**AMERICAN FORK CITY
PLANNING COMMISSION REGULAR SESSION
OCTOBER 16, 2019**

Notice is hereby given that the American Fork City Planning Commission will meet in regular session on October 16, 2019 at the American Fork City Hall, 31 North Church Street, commencing at 7:00 p.m. The agenda shall be as follows:

This report is a summary of the American Fork City Engineering Division plan review comments regarding the subject plan as submitted by the applicant for American Fork City Land Use Authority approval:

ELEVATIONS

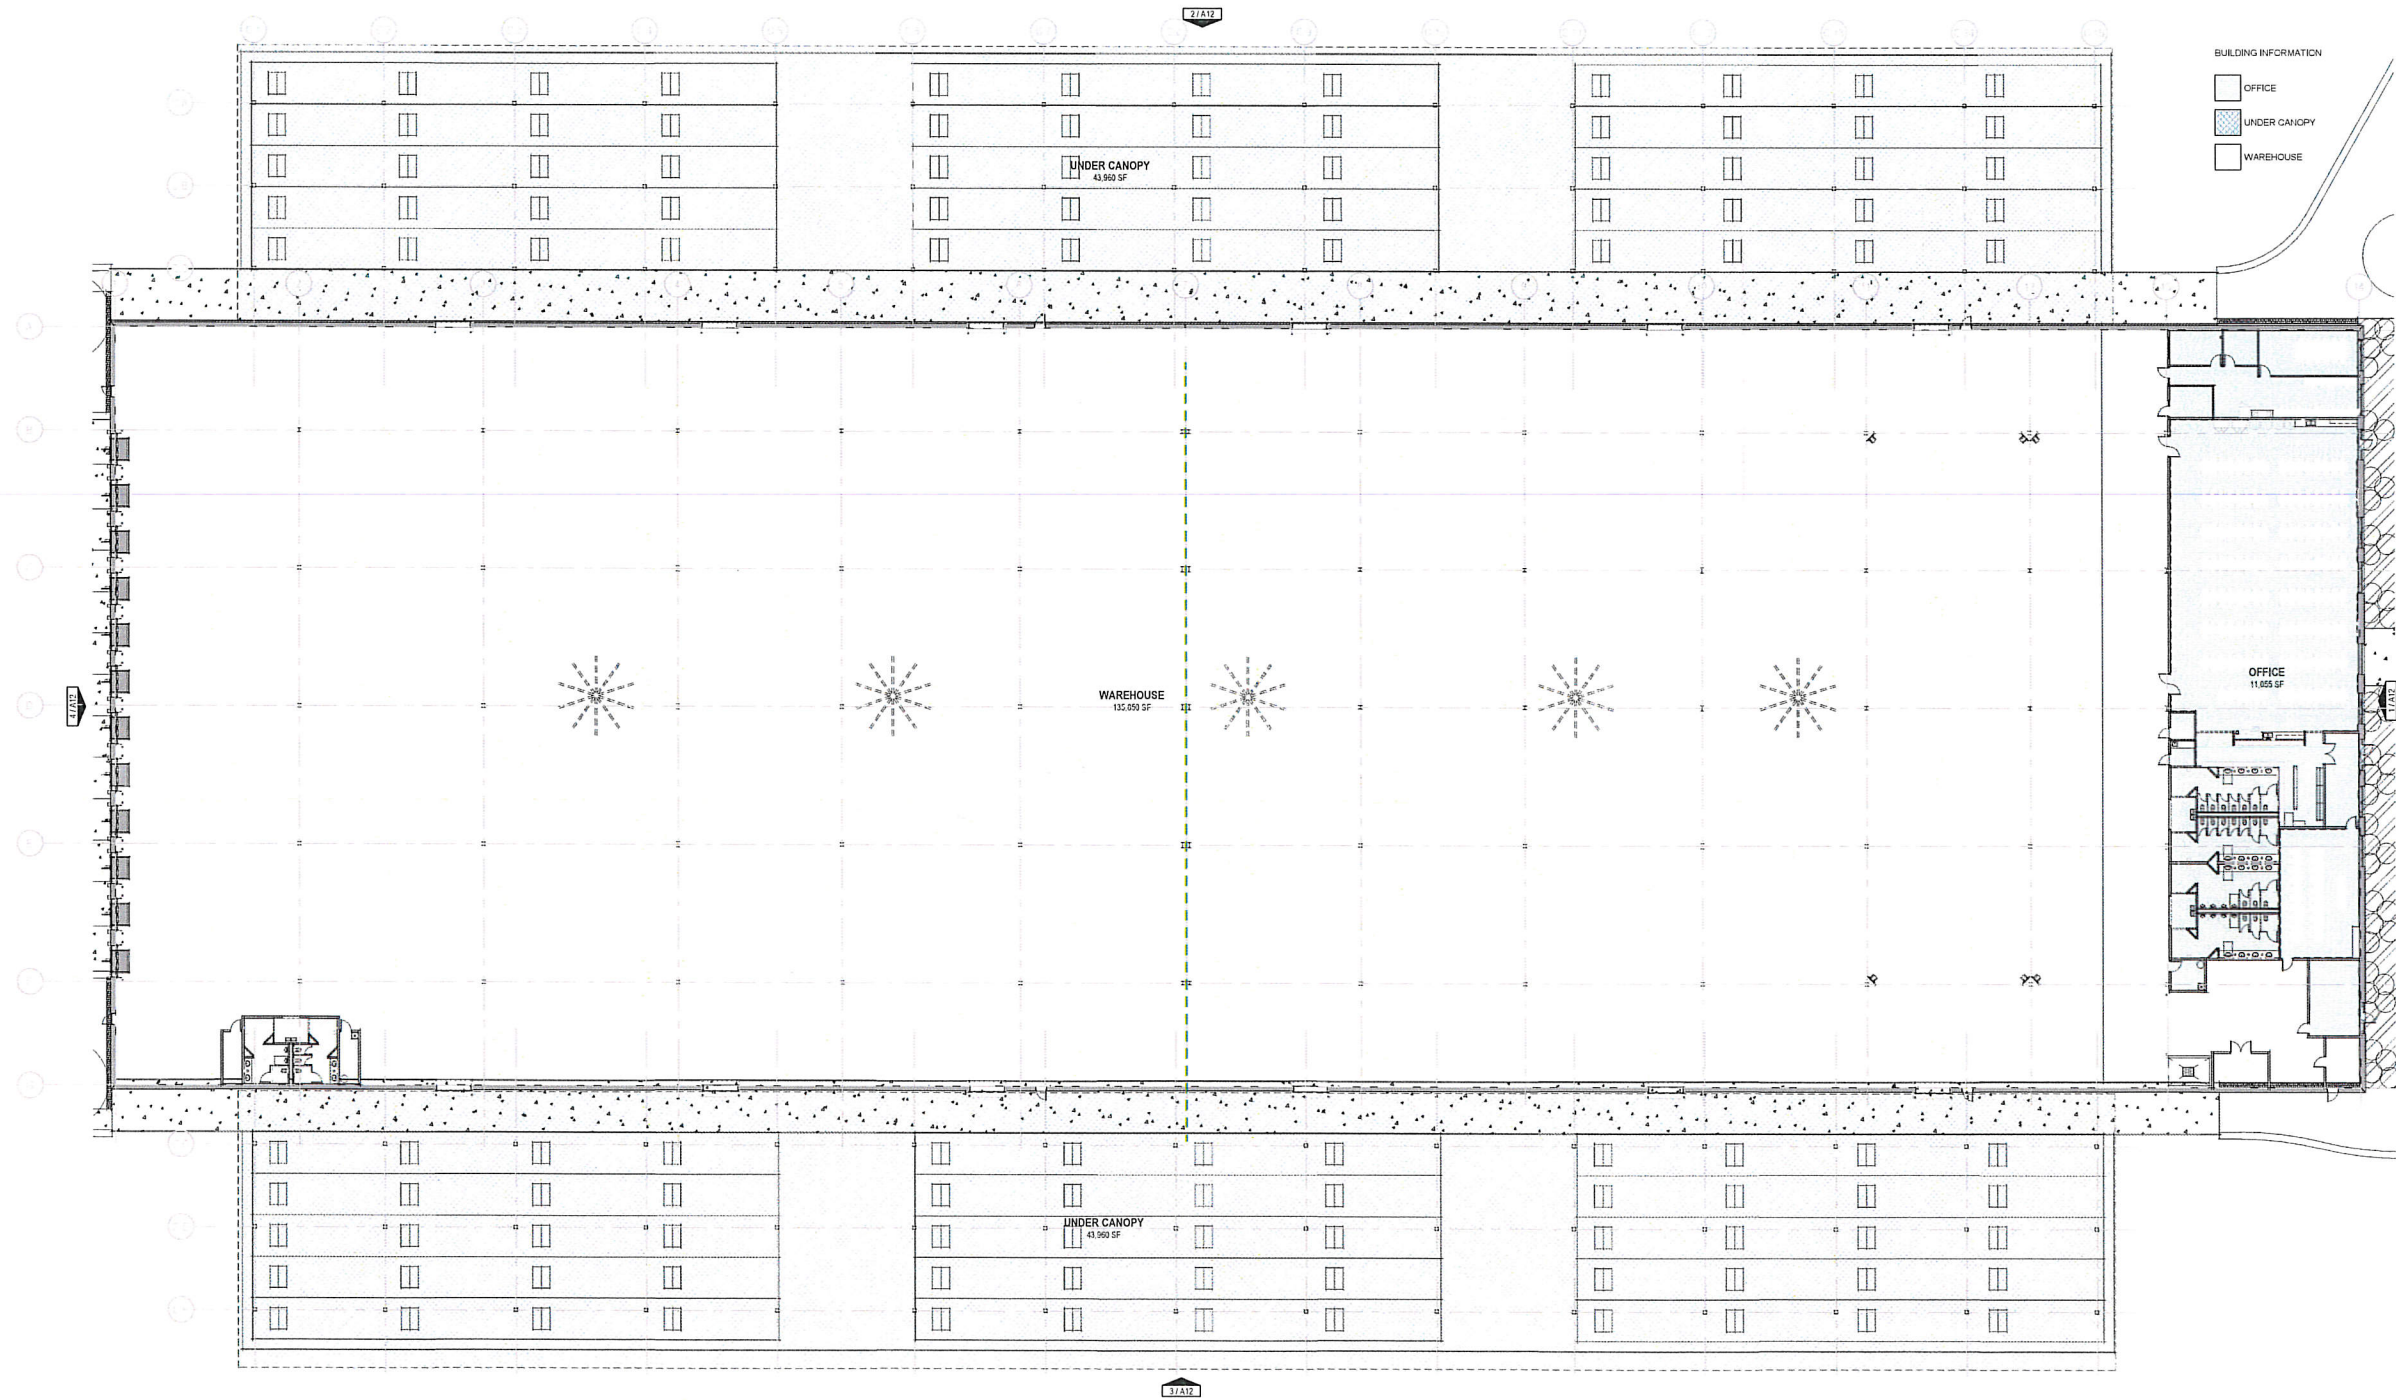
1. Recommended improvements per traffic analysis must be incorporated into the construction plan set.
2. Incorporate redline comments from staff TRC into the construction plan set.
